# Response to TfL Comments

Title: **Hayes Park West – Response to TfL Comments**

## **APPENDIX A1 SEW – DESIGN AND ACCESS ADDENDUM**

**Addendum:  
response to  
Hillingdon and  
GLA comments**

## Urban Design Comments, Addendum UD6B: Proposed parking strategy for Courtyard

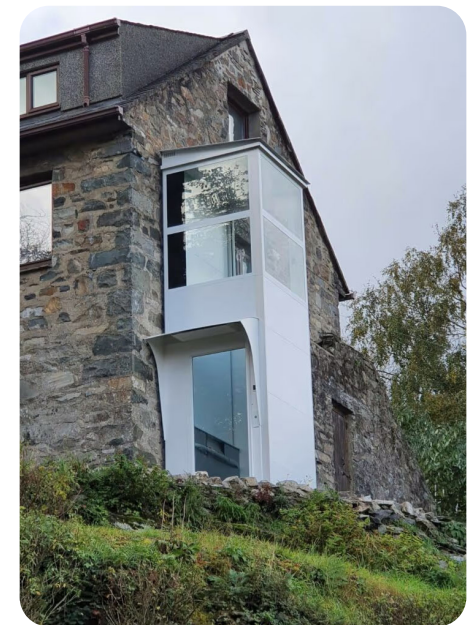
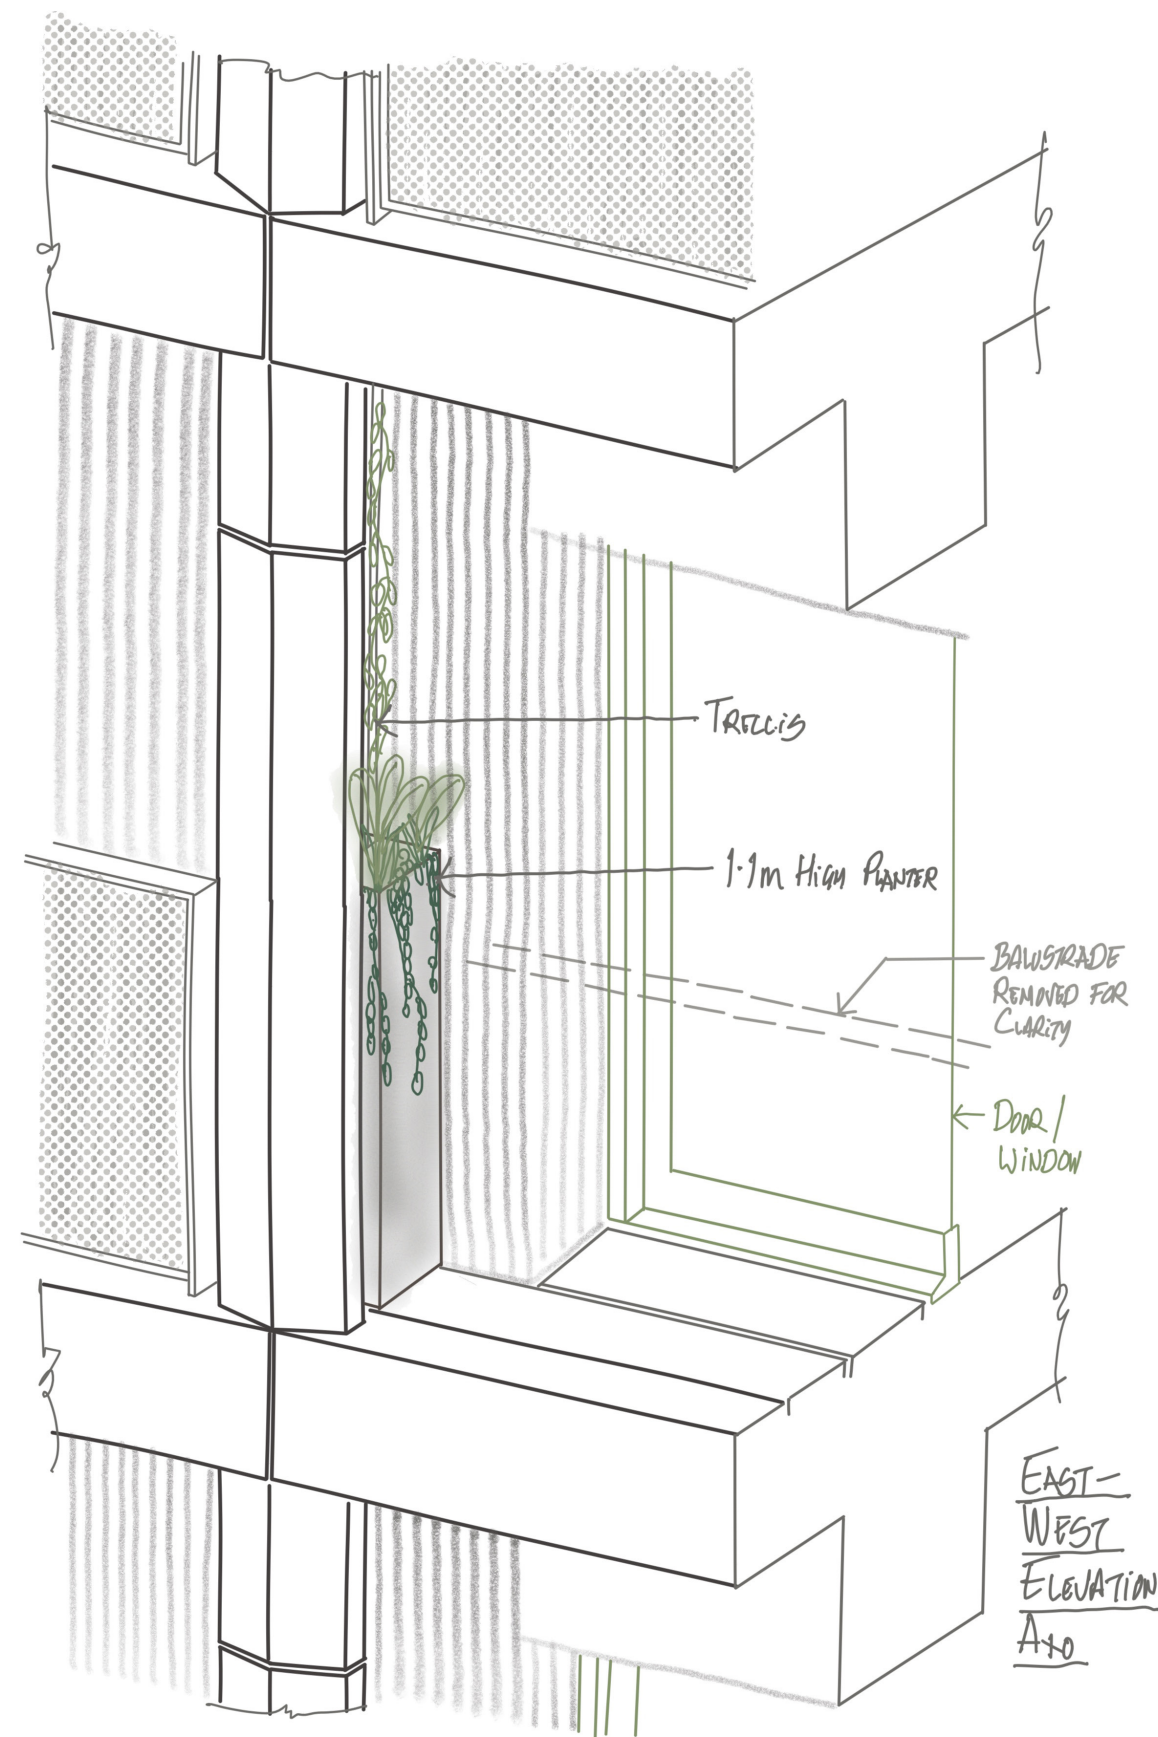
**A external platform lift will provided to allow level access from the front podium to the internal courtyard garden.**

Wheelchair and ambulant disabled users can call the lift at the ground floor podium and travel to the lower ground floor and access the rear courtyard via the car park. Similarly the lift can be taken from the lower ground floor (where the car park is located) up to the podium level.

The lift shall be Approved Document Part M (ADM) compliant a minimum plan area of 1100mm by 1400mm. All the controls shall be compliant with ADM.

## Urban Design Comments, Addendum, UD6H: Balcony Privacy Screen

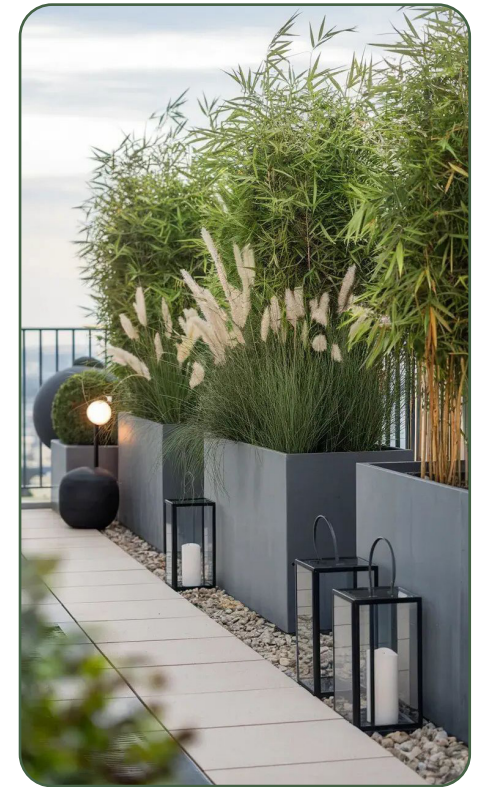
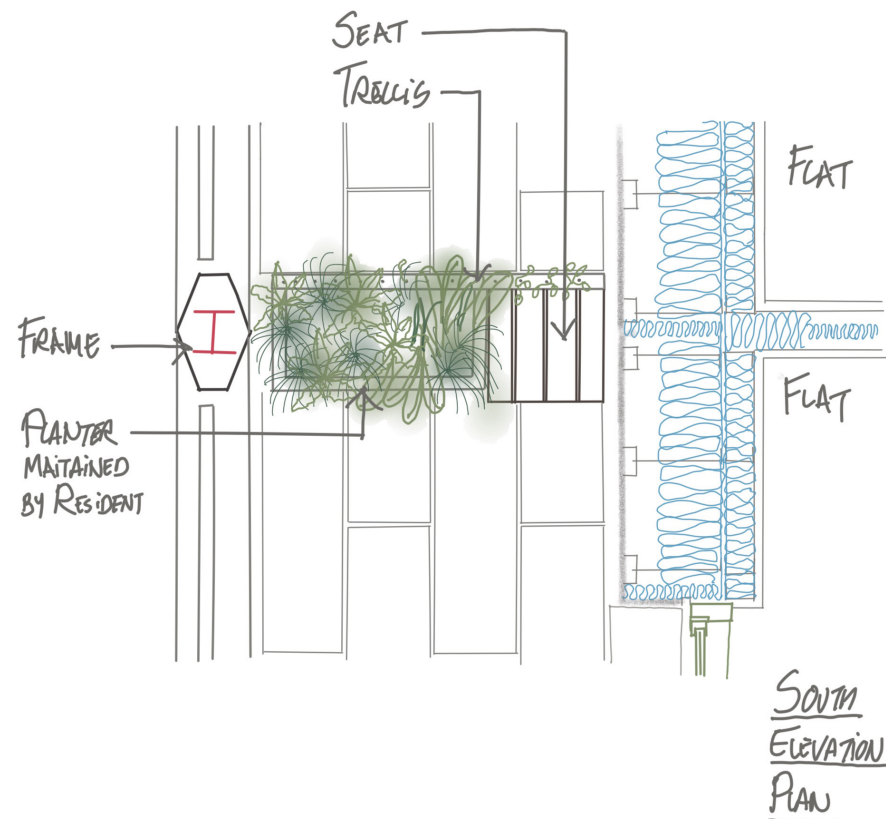
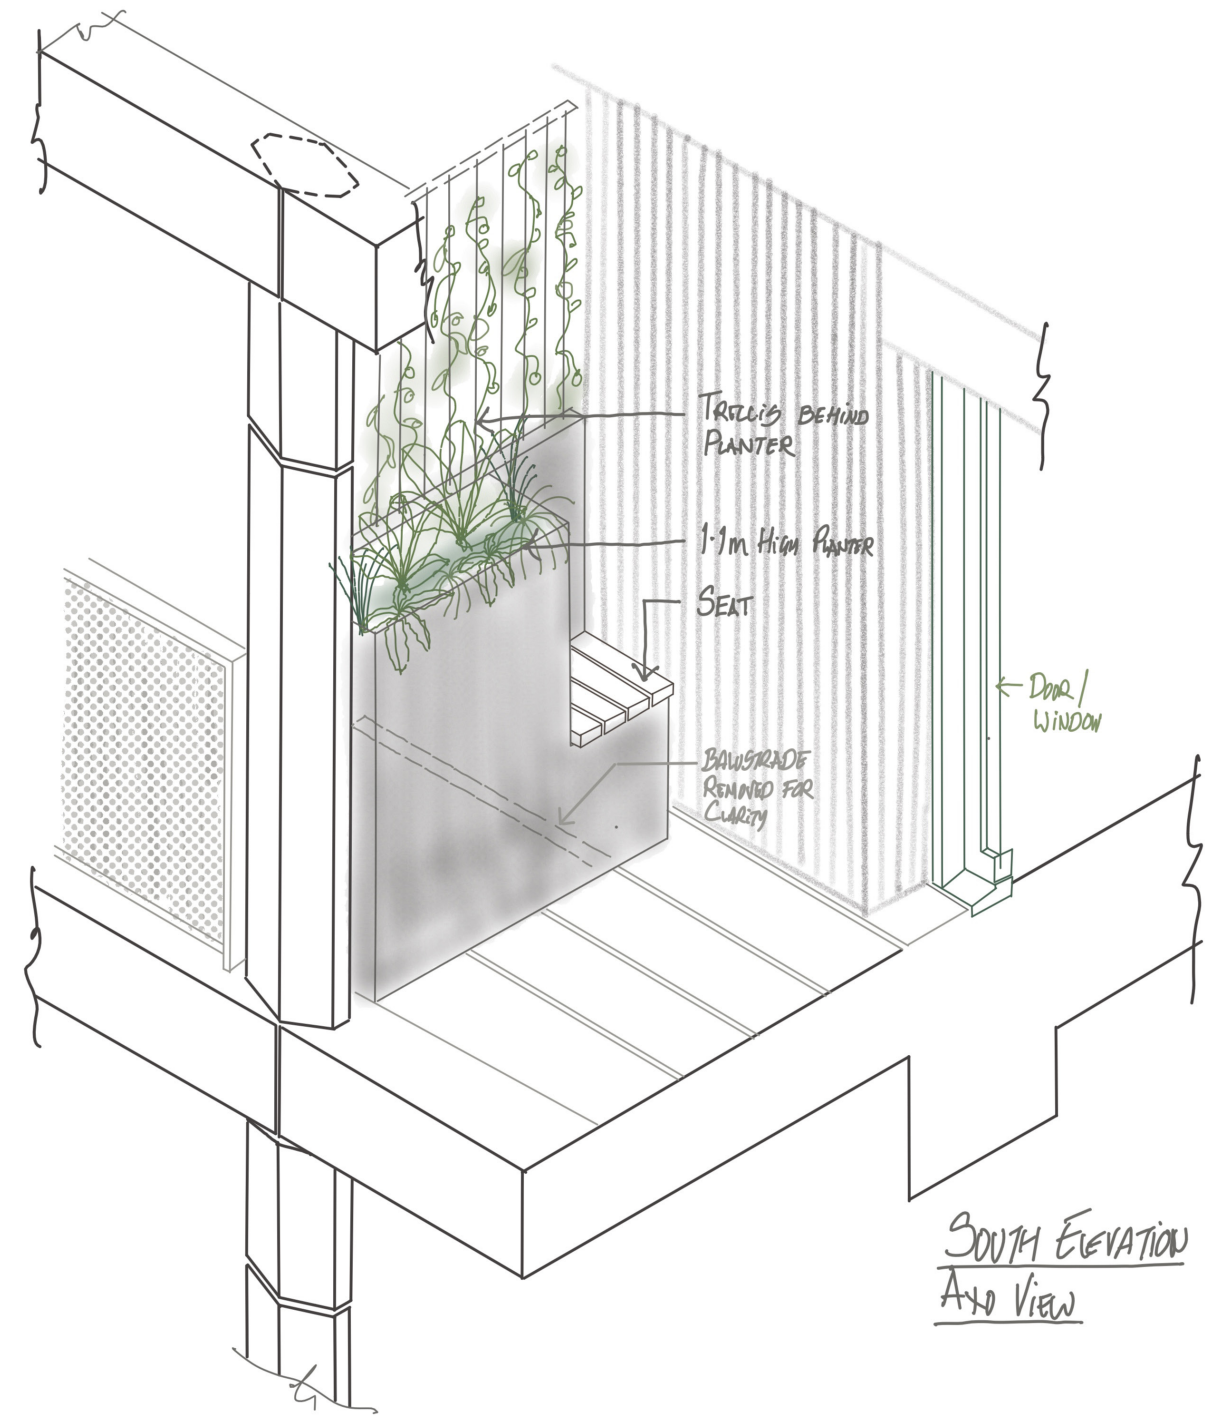
**Privacy is important to foster a community. Our proposal seeks to ensure privacy and interaction, using nature and planting.**

To provide a robust privacy screening we propose a solid planter that can be shared with a neighbour. To the East and West elevations, the planter is 1.1m high to tie in with the balustrade datum. In addition a shared trellis is shown at the back of the planter. The trellis is made from metal wires that span from the planter to the soffit. It allows the residents to grow their own climbing plants, that be nurtured individually or between neighbours. The density of the trellis can be increased in dialogue with your neighbour.

To the south elevation, the 1.1m high planter is lengthened and includes a bench. The wider planter gives more options to explore new planting. A bench nearby the elevation provides an opportunity to rest and enjoy the wider terrace. The planter is maintained by the resident on the lower side, next to their seat. Using this arrangement there will be at least one planter for each flat.

A metal trellis with vertical wires is located at the back of the planter and seat to provide a robust but transparent screening. A shared trellis is shown that can be grown individually or between neighbours. The density of the trellis can be increased in dialogue with your neighbour.

## Urban Design Comments, Addendum, UD6K: Proposed vehicular main access strategy with managed delivery

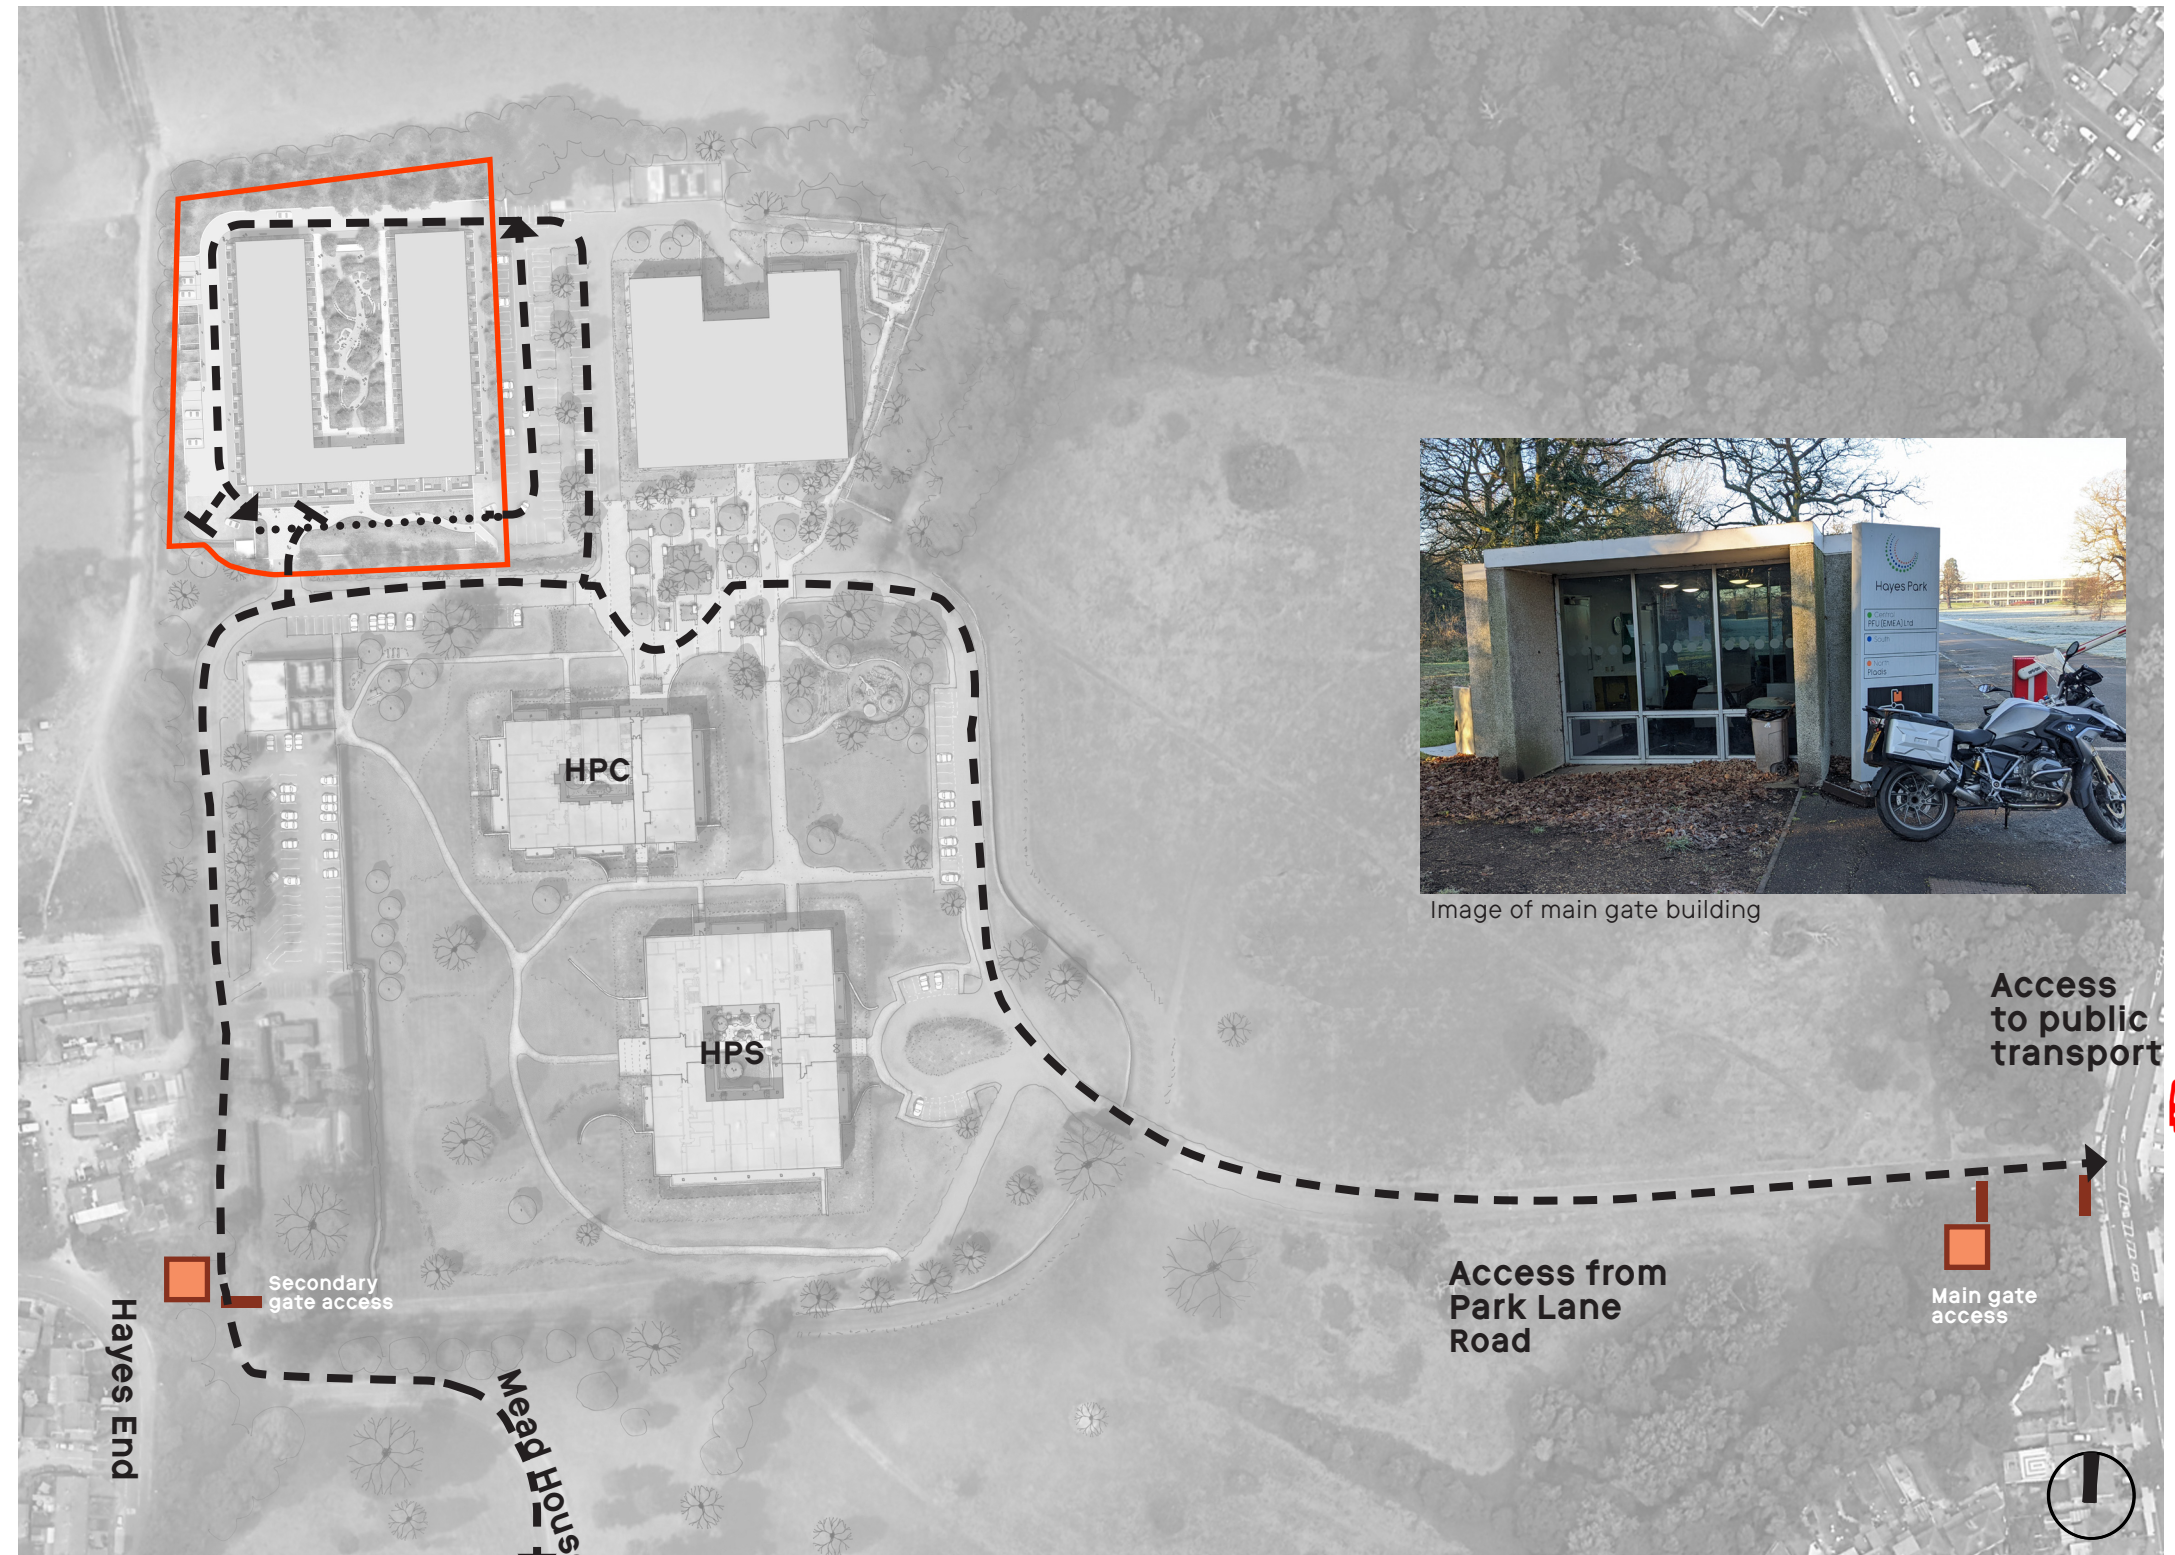
The proposed access strategy looks to reuse the existing access points and estate road.

Each vehicular entry point will be gated, with residents only access controlled by fobs.

There is an opportunity to reuse the existing main gate entrance building as a concierge. This will form part of a wider management strategy for the whole estate. Deliveries to the site will be dropped off at the Main Gate Buildings on Park Lane Road, and Hayes End Road. These Buildings will be occupied during standard working hours.

**GLA Comments item 42, Addendum: Main Pedestrian routes through the site**

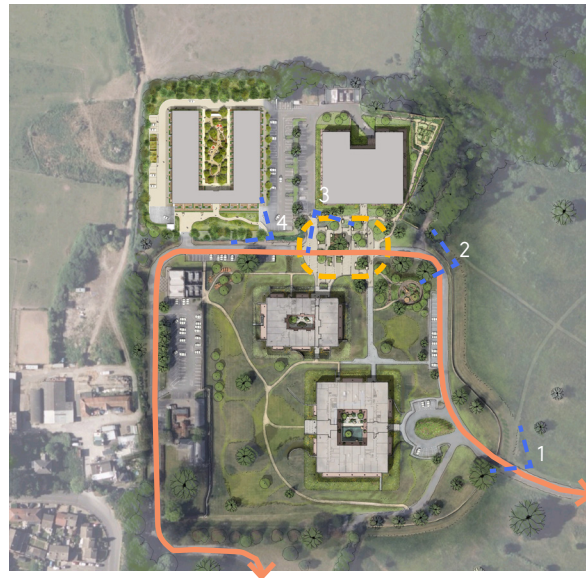
The current arrangement highlights a car-dominated layout, which conflicts with the Healthy Streets approach and Vision Zero principles that aim to prioritise walking and cycling and reduce road danger. To address these issues, car parking provision at the site should be reduced to prioritise safe, dedicated pedestrian and cycle routes. This should be supported by clear wayfinding, and inclusive access points that do not rely on passing through adjacent car parks.

The site is not dominated by cars, there are many pedestrian routes beside the road or within the Pastoral Parkland landscape.

The pedestrian routes beside the road offer an open aspect to the Pastoral Parkland. The car speeds will be curtailed by the narrow carrageway and the frequent turns. Shared surfaces will reduce the car speeds through the site. Towards the north the cars will enter the car park.
